CITY AND COUNTY OF HONOLULU'S  
SAND ISLAND WASTEWATER  
TREATMENT PLANT APPLICATION  
FOR A MODIFIED NPDES PERMIT  
UNDER SECTION 301(h) OF THE  
CLEAN WATER ACT

DECISION OF THE  
REGIONAL ADMINISTRATOR  
PURSUANT TO 40 CFR PART 125  
SUBPART G

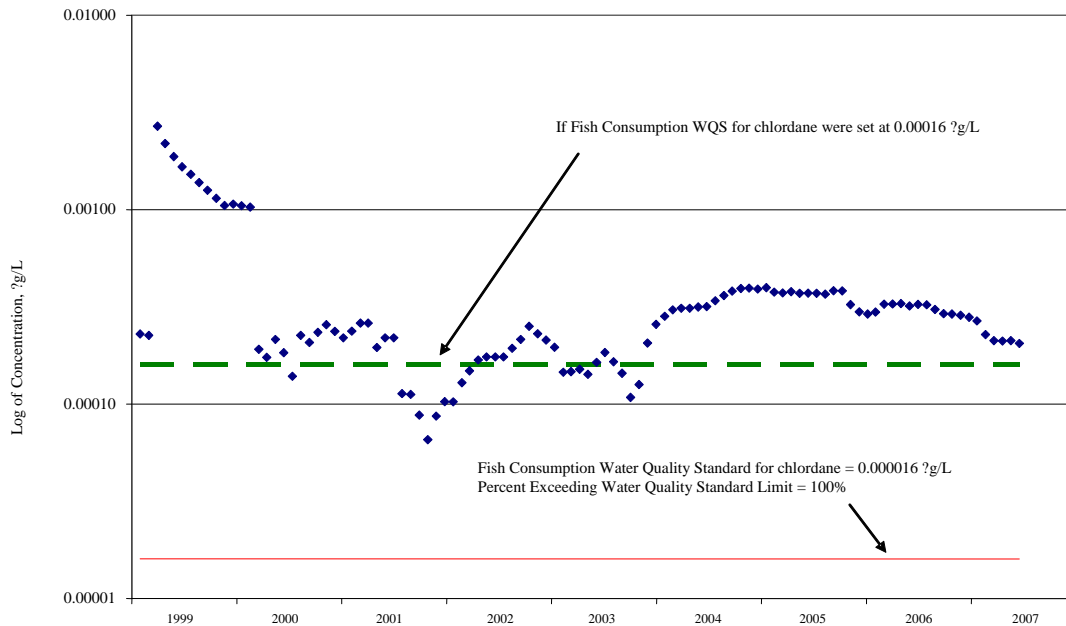
concentrations as a running annual average. Reported annual average chlordane concentrations ranged from 0.019 to 0.79  $\mu\text{g/L}$ . After applying the average initial dilution value of 294:1 to the reported annual average chlordane values, the State water quality criterion of 0.000016  $\mu\text{g/L}$  for chlordane, which protects human consumption of fish, was exceeded in all 105 months. The range of estimated chlordane concentrations at the ZID was 0.000066 to 0.0027  $\mu\text{g/L}$ , as depicted in Figure 3a below.

Nevertheless, EPA evaluated whether the State water quality standard for fish consumption for chlordane would be exceeded if it were changed to 0.00016  $\mu\text{g/L}$ , rather than remaining at the existing value of 0.000016  $\mu\text{g/L}$ . EPA's evaluation found that this less protective limit would have still been exceeded in 87 of 105 months (see Figure 3a).

Figure 3b. Older Sand Island WWTP dieldrin effluent data. Running annual average based on monthly samples collected December 1998 through August 2007 adjusted for the average initial dilution of 294:1.

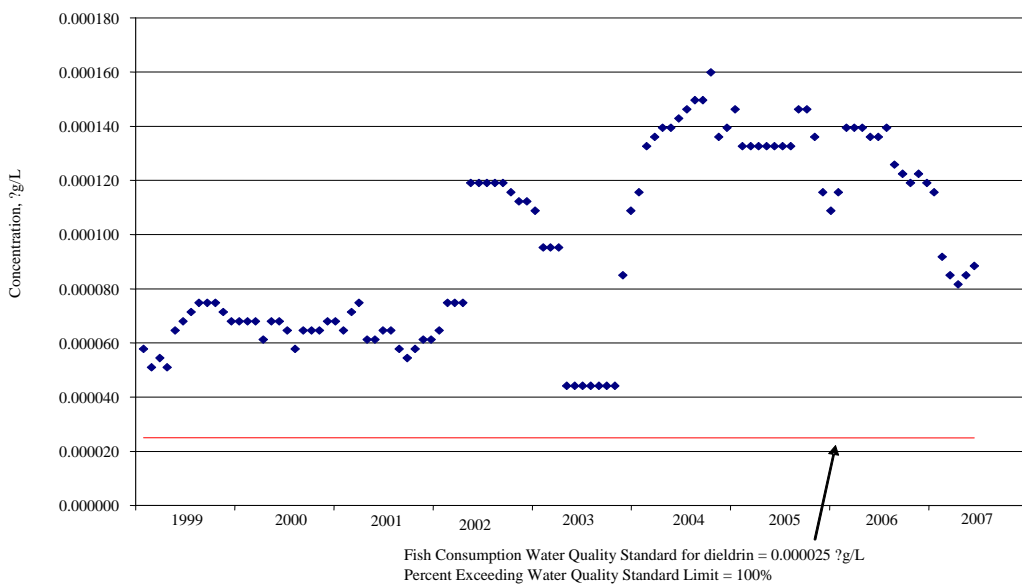
In DMRs, reported annual average dieldrin concentrations range from 0.013 to 0.047  $\mu\text{g/L}$  for the same 105 month period from December 1998 through August 2007. After applying the average initial dilution value of 294:1, estimated dieldrin concentrations ranged from 0.000044 to 0.00016  $\mu\text{g/L}$  at the ZID, as depicted in Figure 3b below. The State water quality criterion of 0.000025  $\mu\text{g/L}$  for dieldrin, which protects human consumption of fish, was exceeded in all 105 months.

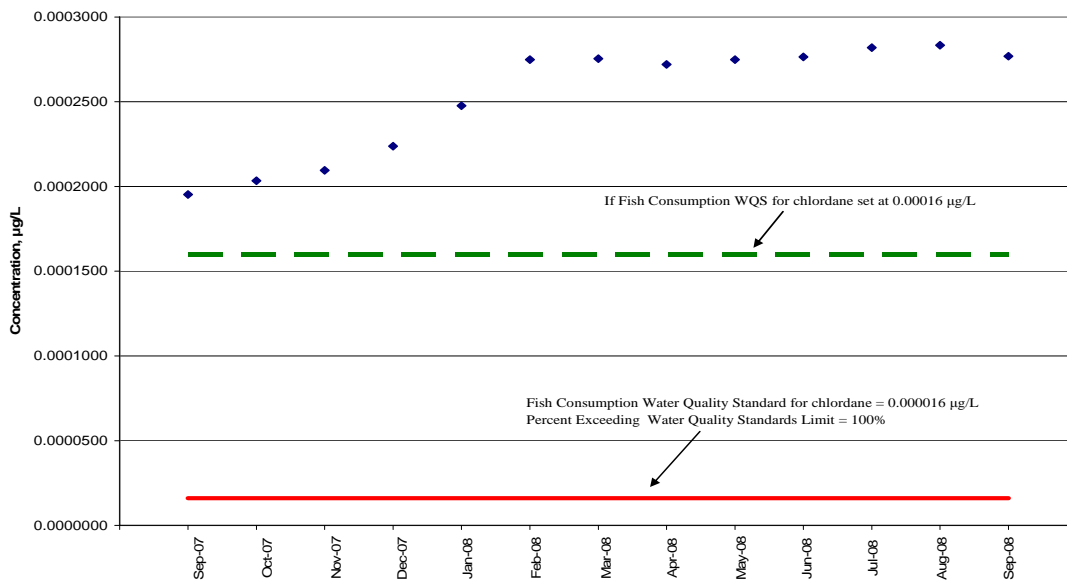
In the 13 months from September 2007 through September 2008, all 13 annual average values for chlordane exceeded the water quality criterion of 0.000016 µg/L, after accounting for average initial dilution. Annual average chlordane concentrations ranged from 0.0002 µg/L to 0.00028 µg/L, as depicted in Figure 3c below.

In total, all of the 118 annual average concentrations for chlordane exceed the human health water quality criterion, when accounting for average initial dilution. EPA is, therefore, retaining its conclusion that the proposed discharge will not attain the water quality criterion for chlordane protective of human consumption of fish.

Figure 3d. Recent Sand Island WWTP dieldrin effluent data. Running annual average for September 2007 through September 2008 based on monthly samples adjusted for average initial dilution of 294:1.

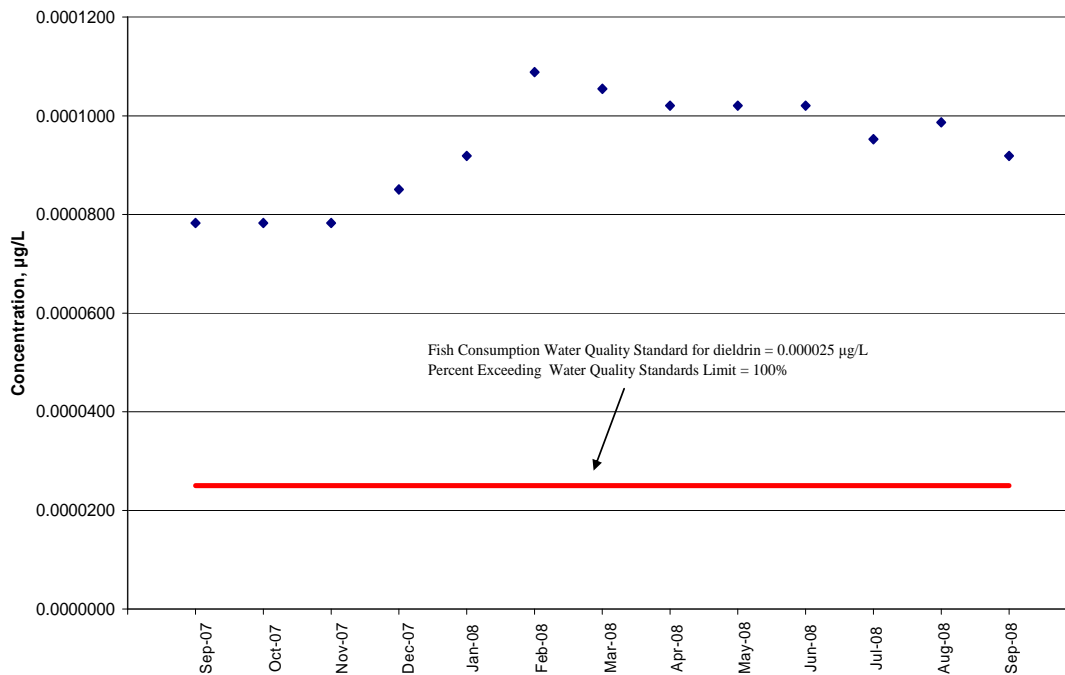
In the 13 months from September 2007 through September 2008, all 13 annual average values for dieldrin exceeded the human health water quality criterion of 0.000025 µg/L, after accounting for average initial dilution. Annual average dieldrin concentrations ranged from 0.000078 µg/L to 0.00011 µg/L, as depicted in Figure 3d below.

In total, all of the 118 annual average concentrations for dieldrin exceed the human health water quality criterion, when accounting for average initial dilution. EPA is, therefore, retaining its conclusion that the proposed discharge will not attain the water quality criterion for dieldrin protective of human consumption of fish.

Figure 3e. Sand Island WWTP daily maximum (TU<sub>c</sub>) whole effluent toxicity test results using *T. gratilla*, January 1999 through May 2007.

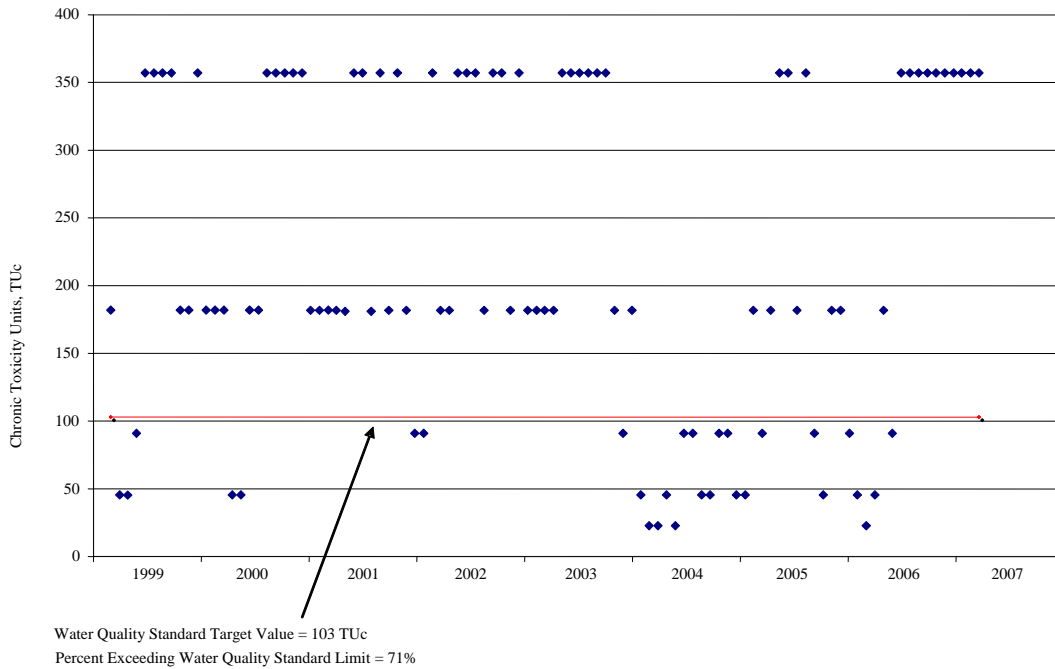
EPA also reviewed WET data reported in DMRs from tests conducted with *T. gratilla*. The TU<sub>c</sub> and NOEC values resulting from toxicity tests conducted from January 1999 through May 2007 are listed in Table 6 and shown in Figure 3e below. Seventy-two of the 101 daily maximum results exceed the current water quality standard target value of 103 TU<sub>c</sub>.

Figure 3f. Sand Island WWTP daily maximum (TU<sub>c</sub>) whole effluent toxicity test results using *T. gratilla*, June 2007 through October 2008.

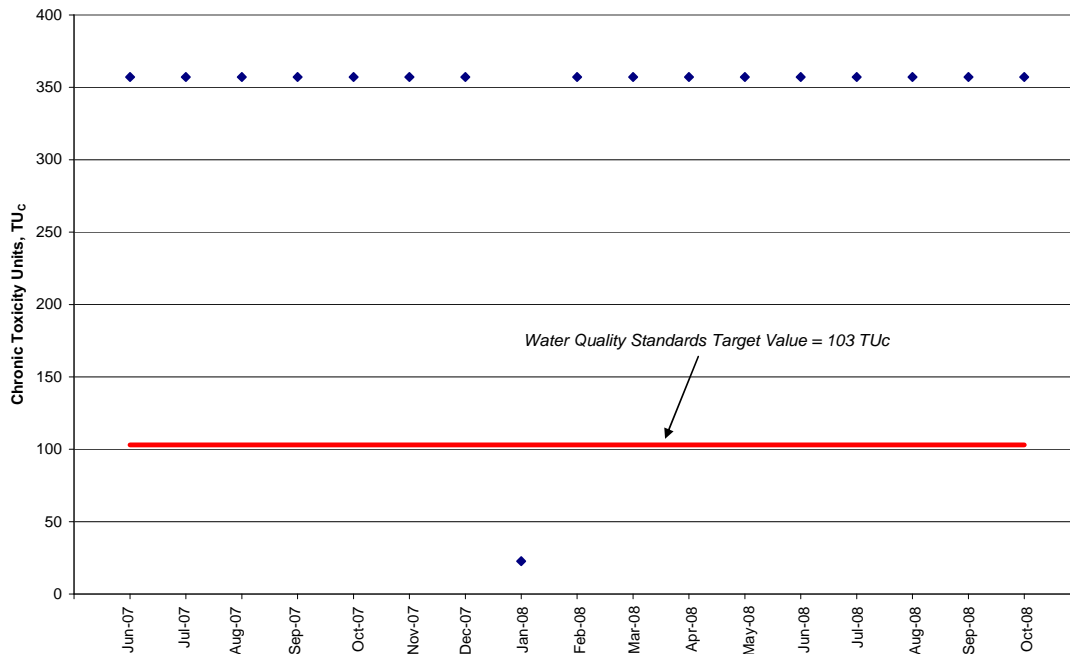
EPA reviewed additional WET data using *T. gratilla* reported by CCH subsequent to the tentative decision. Data reported in DMRs for the months from June 2007 through October 2008 continue to show exceedances of the State water quality standard. The TU<sub>c</sub> values resulting from toxicity tests conducted for this period are listed in Table 6a and shown in Figure 3f below. Sixteen of the 17 daily maximum values for the months during this period exceed the water quality standard target value of 103 TU<sub>c</sub>.

For the overall period from January 1999 through October 2008, 88 of the 118 daily maximum values exceed the State water quality standard target value of 103 TU<sub>c</sub>.

Figure 7. Mercury concentrations of akule from 1999-2005.

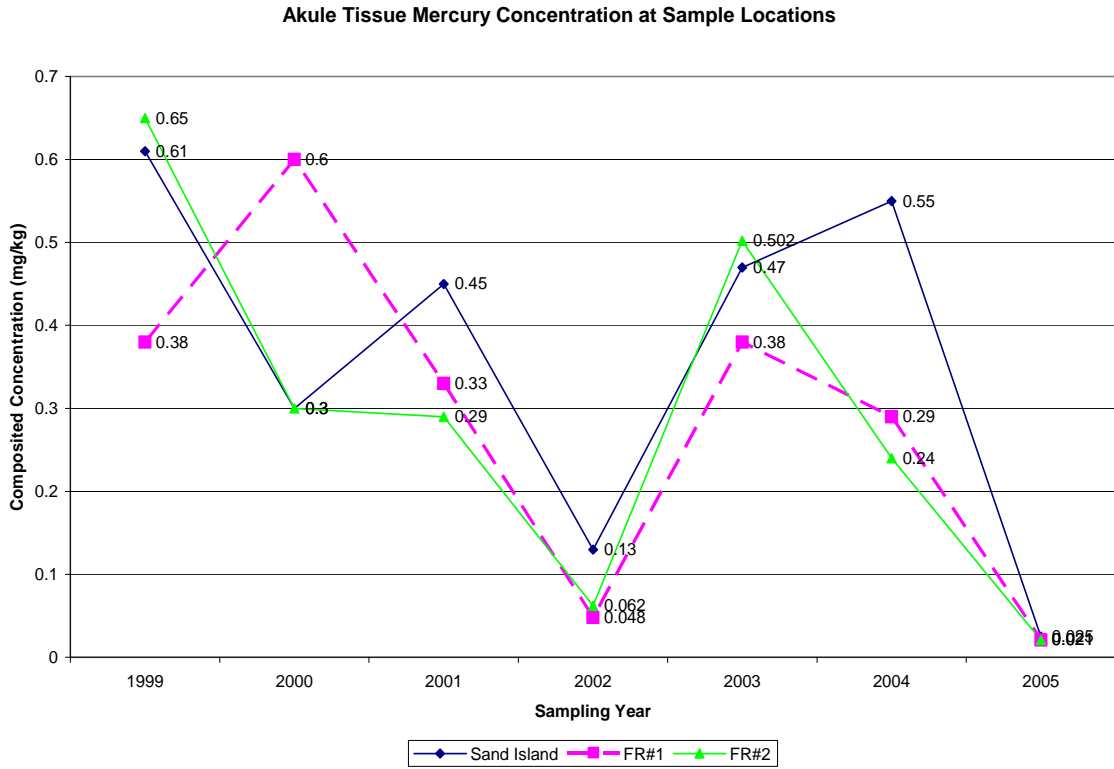
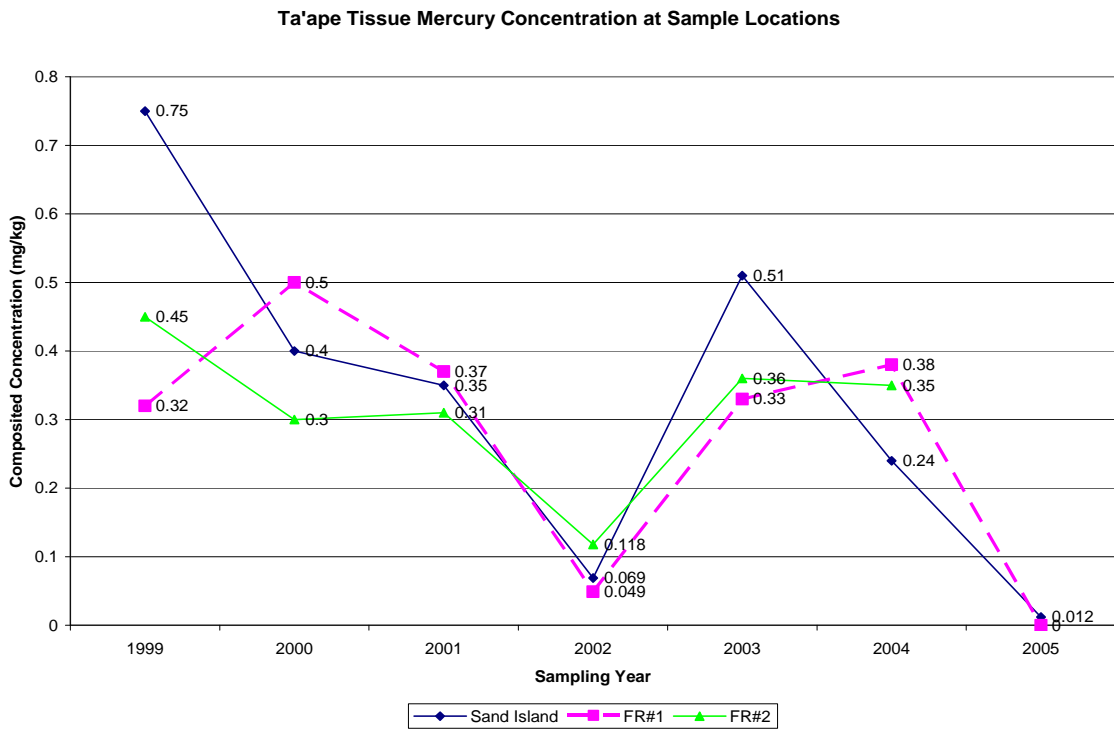
The AARs provide the results for mercury found in fish muscle. A summary of the data is presented in Figure 7 for akule and Figure 8 for ta'ape. The USFDA has established an action level of 1 mg/kg for methyl mercury. All values reported in the AARs are well under 1.0 mg/kg. Additionally, a chronic non-carcinogen screening value for methyl mercury of 0.13 mg/kg was derived by the applicant utilizing methyl mercury's reference dose. Mercury concentrations vary across time and space, as is evident in Figures 7 and 8, but all of the results exceeded the screening value. There was no discernable trend between the reference stations and the station near the outfall, however, so EPA concludes that the levels of mercury in fish tissue are likely not due to the outfall.
